[Docket No. FAA–2023–1814; Project Identifier AD–2023–00773–T; Amendment 39–22541; AD 2023–17–14]

Airworthiness Directives; The Boeing Company Airplanes

ACTION: Final rule; request for comments.

Figure 1 to paragraph (h)(4)—Cap seal minimum thickness (all dimensions in inches)

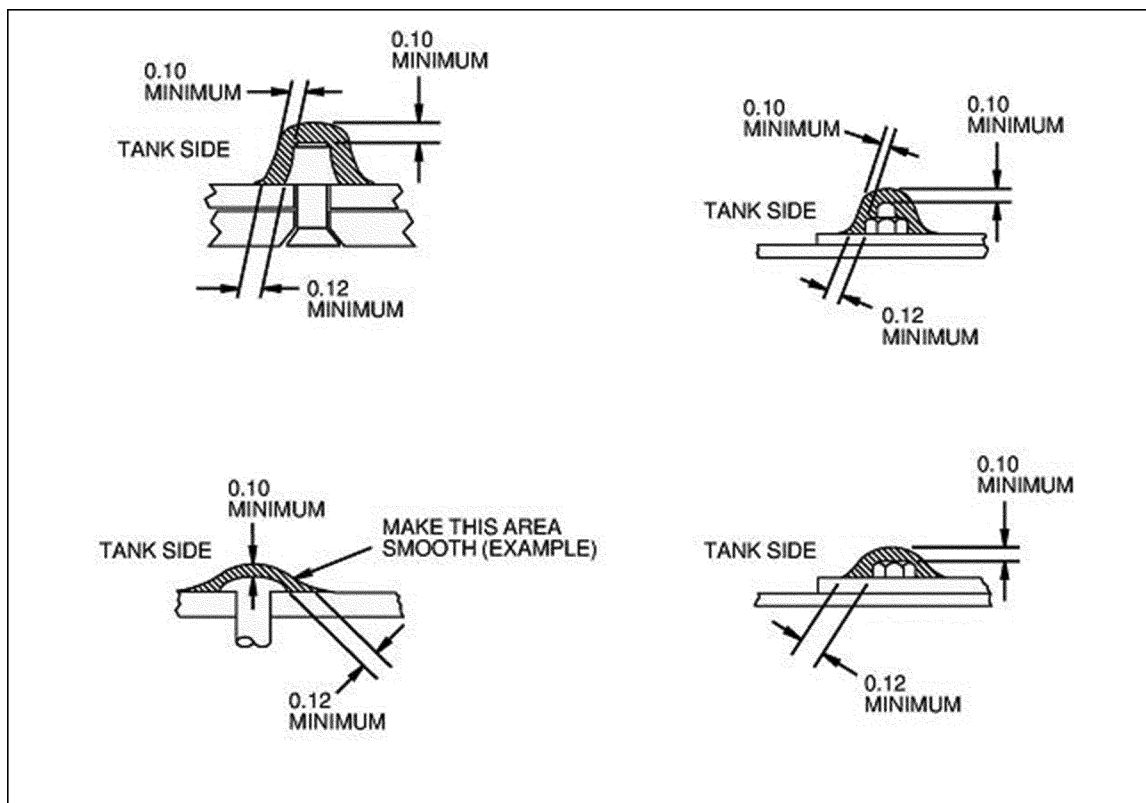
(4) During application of any cap seal to a fastener, fastener head, and fastener threads and collars, as required by this AD, the cap seal must be applied with a thickness equal to or greater than the dimensions specified in figure 1 to paragraph (h)(4) of this AD.

(6) Where Boeing Alert Requirements Bulletin 777-57A0122 RB, dated October 8, 2021, requires inspections that may require the removal of fastener cap seals, this AD requires that if the cap seal is removed, a cap seal of BMS 5-45 sealant be reapplied with a thickness equal to or greater than the dimensions specified in figure 1 to paragraph (h)(4) of this AD before further flight after completion of the inspection.

(ii) All cap seals were applied using procedures with thickness dimensions greater than or equal to those given in figure 1 to paragraph (h)(4) of this AD.

(2) If any cap seal was applied using procedures with thickness dimensions less than those given in figure 1 to paragraph (h)(4) of this AD, or if the maintenance records do not definitively specify the procedures used: At the applicable time specified in paragraph (i)(2)(i) or (ii) of this AD, replace the cap seal in accordance with the Accomplishment Instructions of Boeing Alert Requirements Bulletin 777-57A0122 RB, dated October 8, 2021, using a cap sealing procedure with thickness greater than or equal to the dimensions given in figure 1 to paragraph (h)(4) of this AD.
